Nature of Work: REROOF T/O RESHT 27 SQ TWO STRY INSTALL METAL BATTEN SYSTEM, THERMO SHEATHING & LT WT TILE

re: Job 2003336: CHAN

Subject: Structural Investigation Report of the Roof for the Residence located at 10 Assay Court, Sacramento, CA 95831.

ROOF PLAN - CHAN

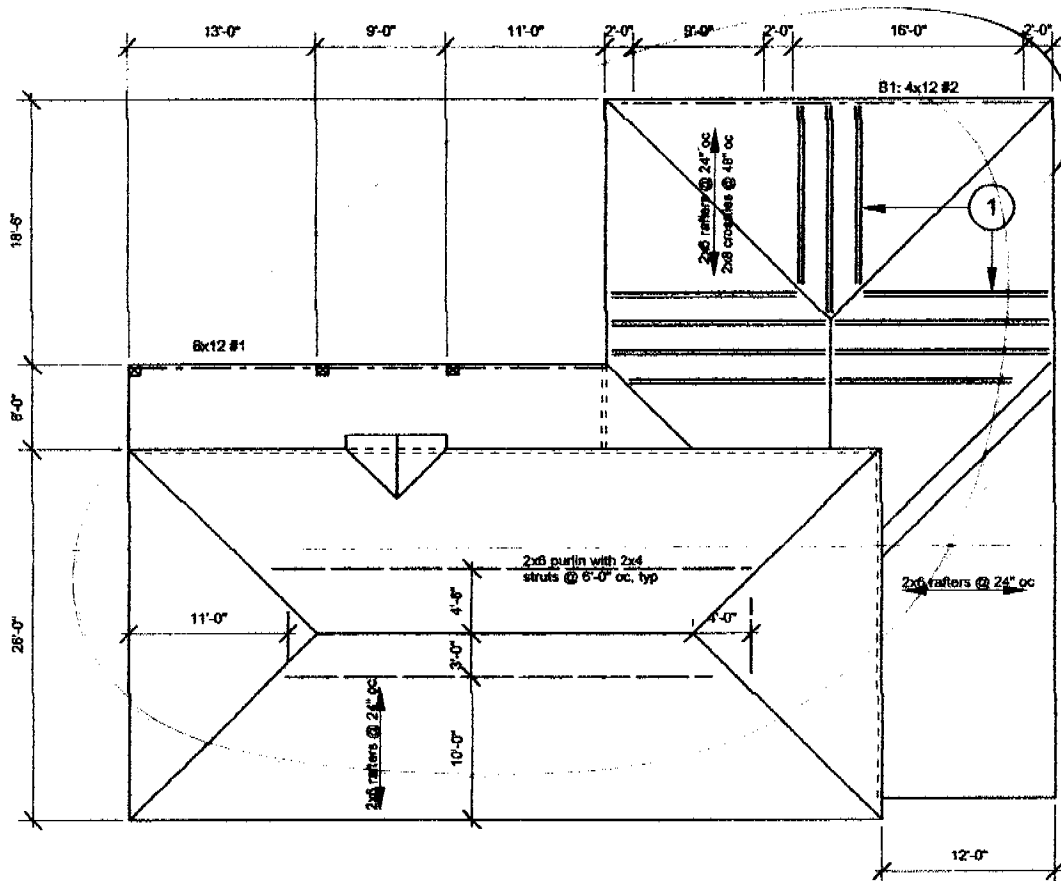
The roof structure currently lacks sufficient structural capacity for the applied live and dead loads. See "Recommendations" for location and repair to bring the roof structure up to the required capacity.

1. Scab a 2x6 rafter to the existing 2x6 rafters with 16d's @ 12" on center where the span is greater than 12'-0". The rafter to be scabbed to the existing rafter may be held short of the intersecting bearing wall, hip, valley, ridge or purlin by no more than 4". See detail 1.

1. Scab a 2x6 to existing 2x6 rafters where the span is greater than 12'-0" (total 9).

- A. This is a reroof project. The new roofing material shall be a Light Weight Concrete Tile. The tile shall weigh less than or equal to 7.3 psf.
- B. All rafters are 2x6 DF#2 and hips and valleys are 2x8 DF#2 unless otherwise noted.
- C. All existing rafter, hips, valleys, rafter ties, and purlins are braced per UBC Section 2320.1 "Roof and Ceiling Framing" unless otherwise shown.
- D. All structural wood members that were observed appear to be in sound condition and without structural defect.
